## CALIFORNIA COASTAL COMMISSION

Page 1 of 2  
Permit Application No. 4-95-219  
Date November 1, 1995

ADMINISTRATIVE PERMIT

PROJECT DESCRIPTION: Replace Cabrillo Blvd. Bridge over Sycamore Creek (incorporating mitigation measures for tidewater goby and riparian vegetation)

CONSTRUCTION DETAILS  
 C-3

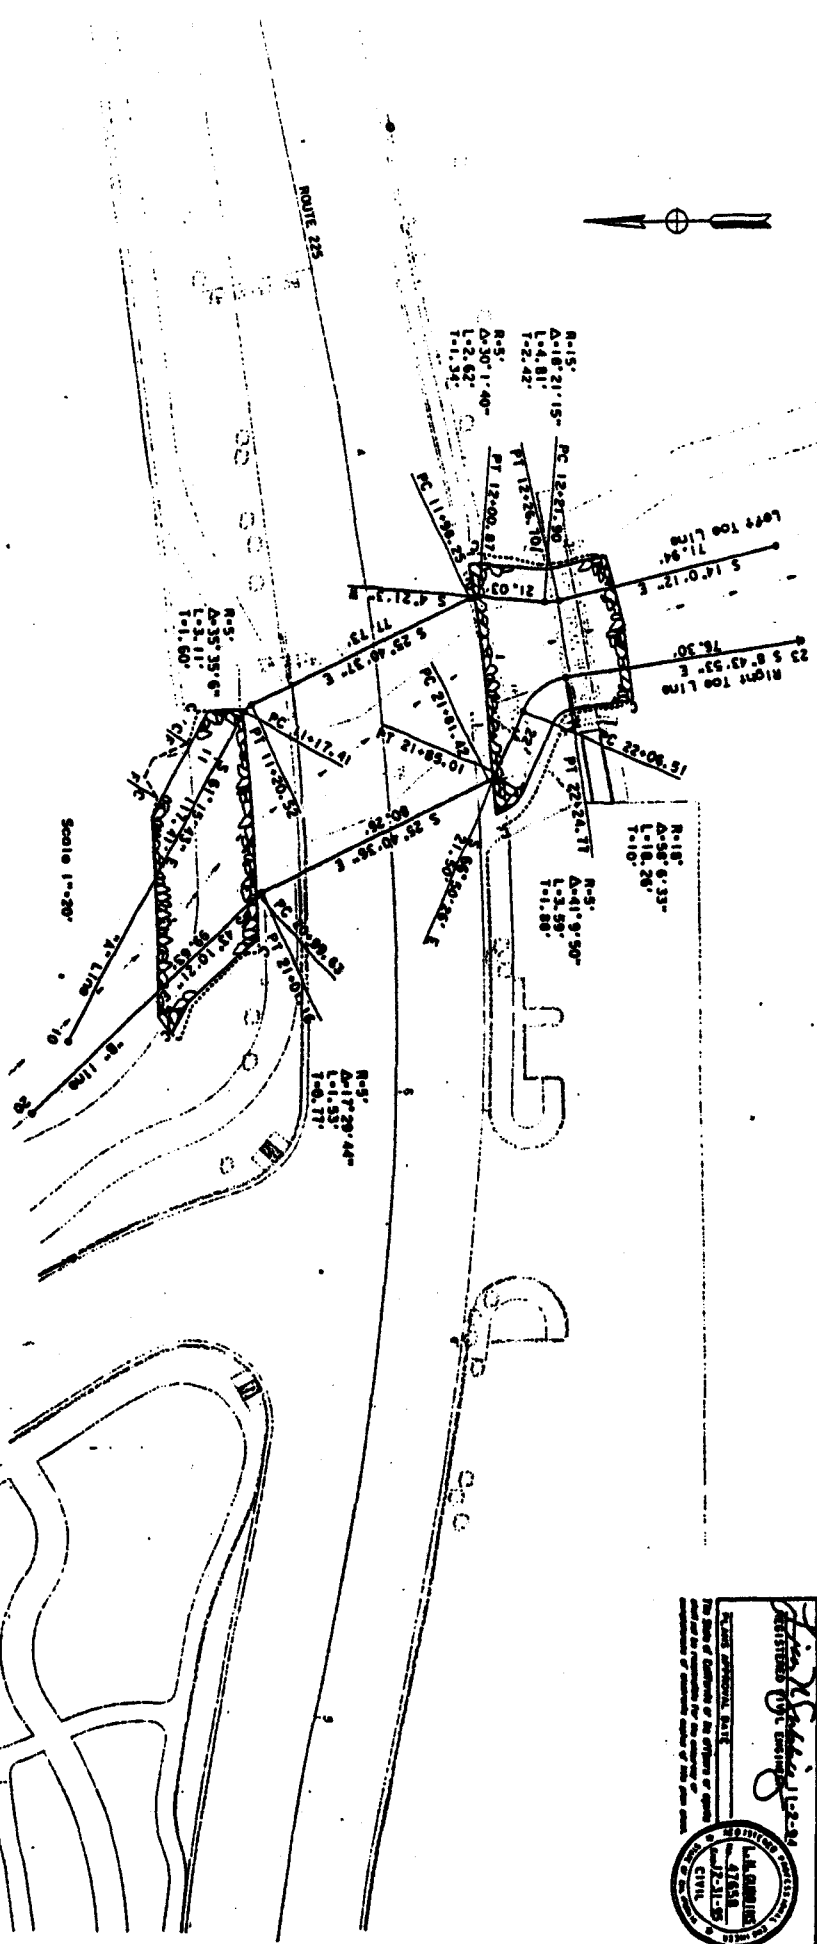
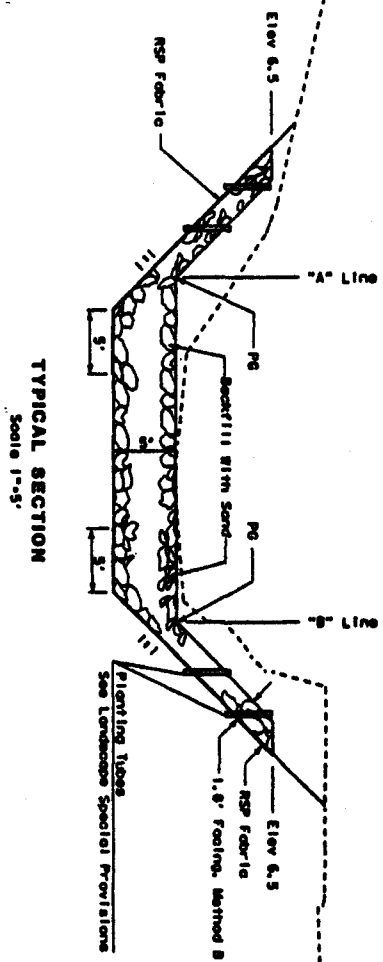
The bridge replacement will require a the temporary removal of the curb planter located near the southwest corner of the bridge, and the removal of a 3-inch Monterey Cypress tree. The planter will be replaced upon completion of the project and the Monterey Cypress tree will be replaced on with a mixture of landscape specimens. Bicycle traffic will be detoured around the construction site for a four-month period during the first phase of construction. (Exhibit 4)

1. The mitigation measures identified in the Biological Opinion prepared by the U.S. Fish and Wildlife Service for this project dated October 21, 1994 those contained in the Department of Fish and Game's 1600 Agreement for this project shall be incorporated into the project description and all bidding documents, and shall be implemented concurrently with the construction of the project. (Exhibit 4)
